Model 1208 - 6 Meter Transverter - PC Board Error

(The arrow in the figure below shows the portion of the junction grounded by the board fault.)

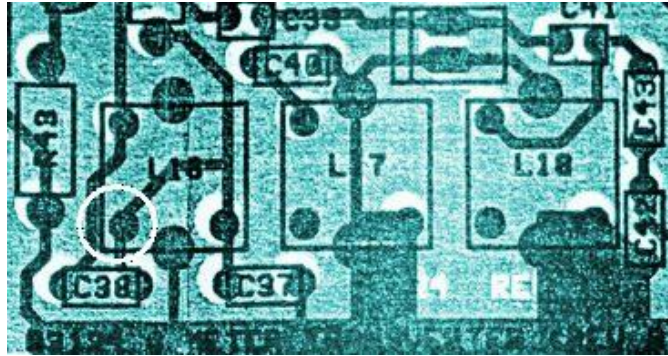
On my board the 3rd hole on L16 connected the upper ground plane to a trace on the underside of the board from C37, C38, R44 and L16 effectively taking all these components to ground. A quick review of the schematic shows this is an error.

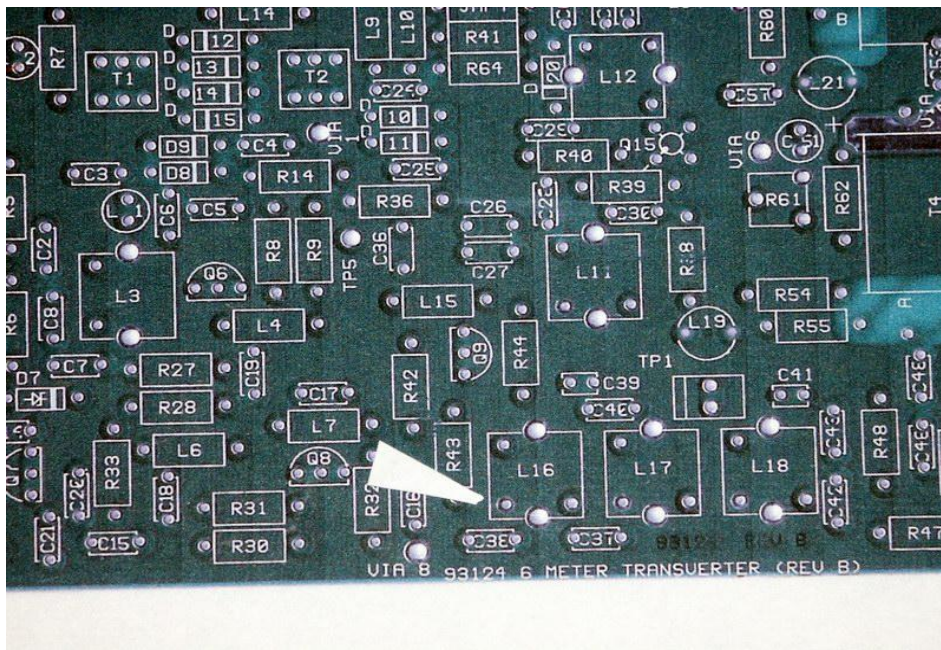
Examination of the X-Ray view shows the problem (see pad inside white circle at lower left of L16). The L17 and L18 pads connect the top ground plane to bottom ground plane BUT L16 connects the top ground plane to a trace on the under side. (Green is component side ground plane, black is underside trace, underside ground plane NOT shown.)

The hole in question (see photo below by the white arrow) was drilled from the top side *just deep enough* to ensure that it no longer was connected to the upper ground plane.
